HISTORIC AND DESIGN REVIEW COMMISSION

October 02, 2019

HDRC CASE NO: 2019-505
ADDRESS: 268 THORAIN BLVD
LEGAL DESCRIPTION: NCB 9009 BLK 5 LOT 12 AND 13
ZONING: R-4,H
CITY COUNCIL DIST.: 1
DISTRICT: Olmos Park Terrace Historic District
APPLICANT: John Bonillas/CASA Exteriros
OWNER: RUEDA GABRIEL ANDRES & RUEDA JAIME & RUEDA LAURA E
TYPE OF WORK: Demolition of garage with new construction
APPLICATION RECEIVED: August 23, 2019
60-DAY REVIEW: October 22, 2019
CASE MANAGER: Stephanie Phillips
REQUEST:

1. Demolish the existing rear garage.
2. Reconstruct the rear garage in the same footprint, height, design, and configuration.

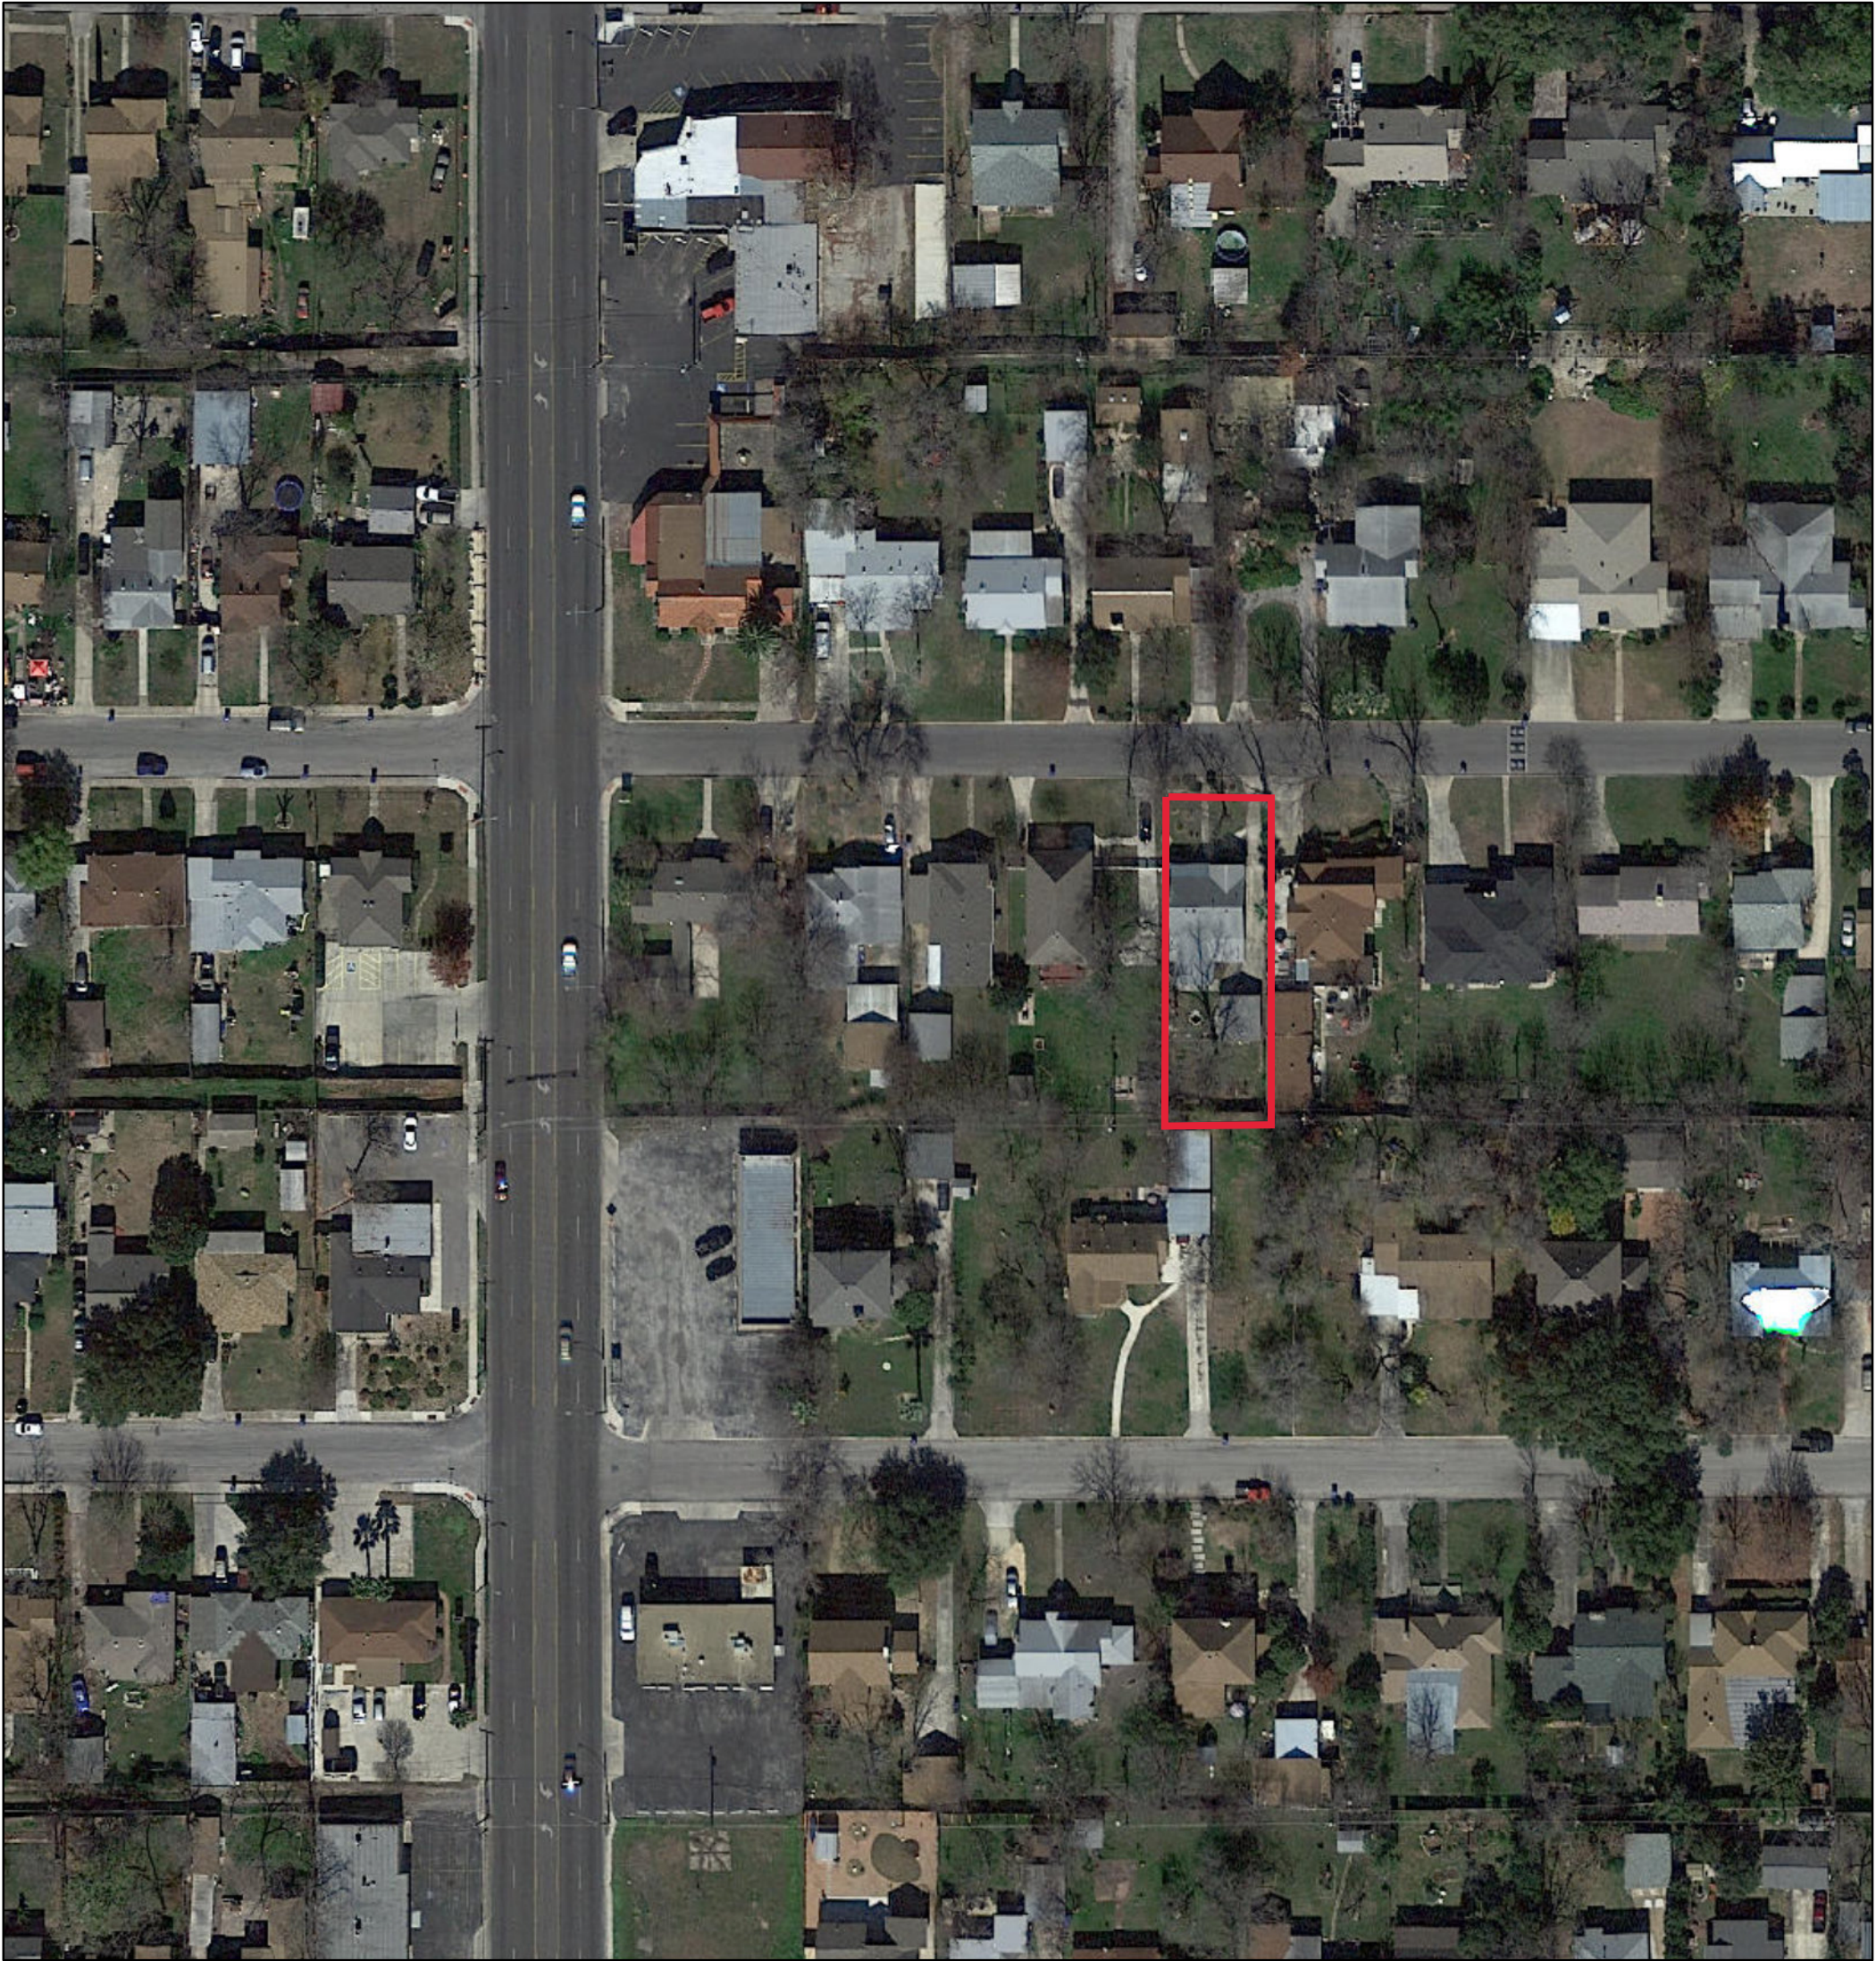
- a. The structure at 268 Thorain Blvd is a 1-story single family house constructed circa 1940 in the Minimal Traditional style with Craftsman influences. The home features a cross gable configuration, stone chimney, and

asymmetrical front porch with a metal shed roof. The structure is contributing to the Olmos Park Terrace Historic District. The property also features a 1-story rear carriage structure with horizontal woodlap siding with a wide reveal, composition shingle roof, exposed rafter tails, and two wooden carriage doors, also contributing to the Olmos Park Terrace Historic District.

- b. RECONSTRUCTION – The applicant has proposed to demolish the existing, rear carriage structure. As noted in finding a, staff finds this rear structure to be contributing to the Olmos Park Terrace Historic District and finds its full demolition to be inappropriate; however, staff finds the demolition and reconstruction of the rear structure to match the existing footprint and architectural details to be generally appropriate.

- c. EXTERIOR MODIFICATIONS – The applicant has proposed to reconstruct the structure to closely match the existing configuration. The garage will feature an open carport configuration and the carriage doors will not be reintroduced. Staff finds that the overall proposal is generally appropriate, but finds that the exterior siding should be reused on the exterior where possible, and the roof form and exposed rafter tails should be retained as character defining features. A comprehensive deconstruction and reuse plan, as well as accurate and detailed construction drawings, is required for a Certificate of Appropriateness to be issued.

Staff recommends approval based on findings a through e with the following stipulations:

- i. That the existing structure is deconstructed versus demolished where feasible and that the existing siding is salvaged where possible to be reused in the reconstruction. A deconstruction and reuse plan should be submitted to staff as that clearly indicates the items to be salvaged and their proposed locations in the new structure prior to the issuance of a Certificate of Appropriateness.
- ii. That the applicant submit final accurate, dimensioned, to-scale drawings for the reconstructed structure to staff prior to receiving a Certificate of Appropriateness. The roof form, including pitch and exposed rafter tails, must be retained in the new structure.
- iii. That the applicant complies with all setback requirements as required by Zoning and obtains a variance from the Board of Adjustment, if applicable.
